SITE PLAN REVIEW

CLIENT
HIGHCASTLE HOMES

PROJECT/LOCATION
RIVERWALK, PHASE 2
BRAMPTON, ON

DRAWING
SITE PLAN

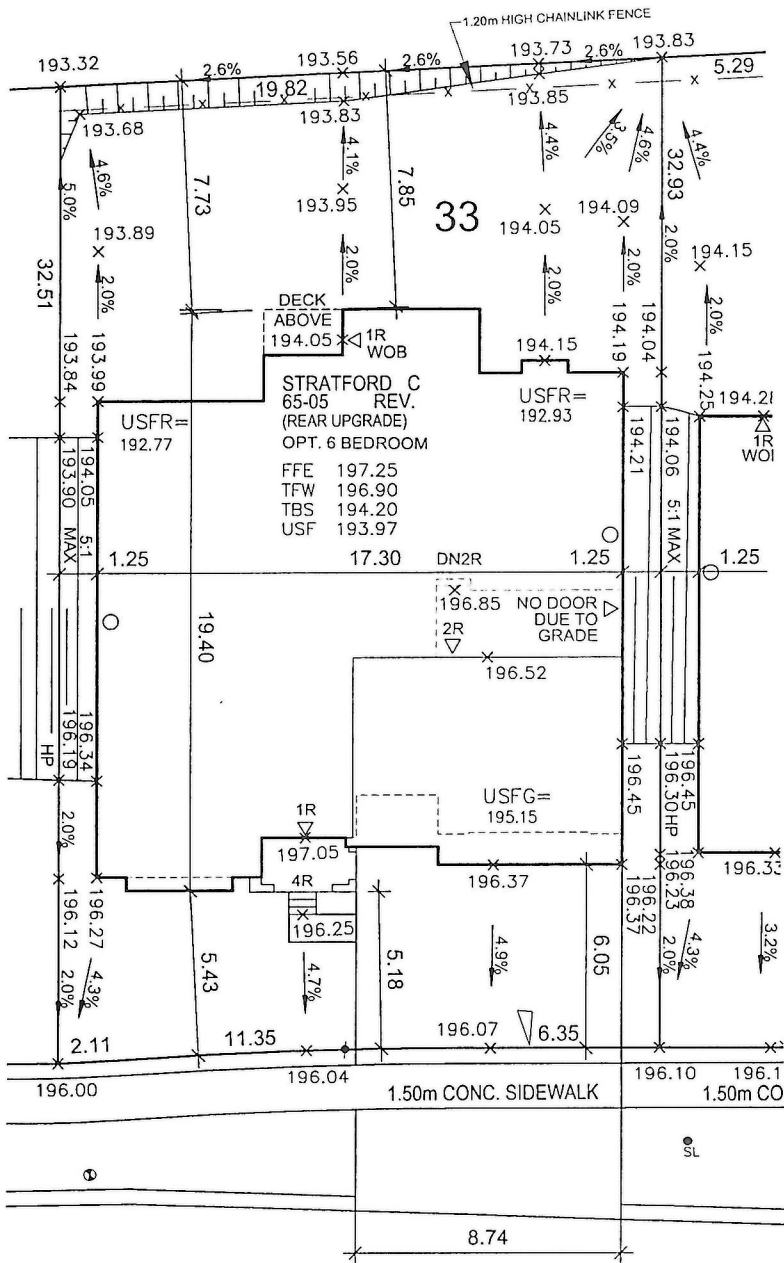
THE PROPOSED LOT GRADING AND DRAINAGE IS APPROVED AS BEING IN CONFORMITY WITH THE OVERALL APPROVED GRADING PLANS FOR THE SUBDIVISION.

NO COMMENT ☒ REVIEWED BY DL
COMMENTS AS NOTED ☐ DATE JUN 20 2016
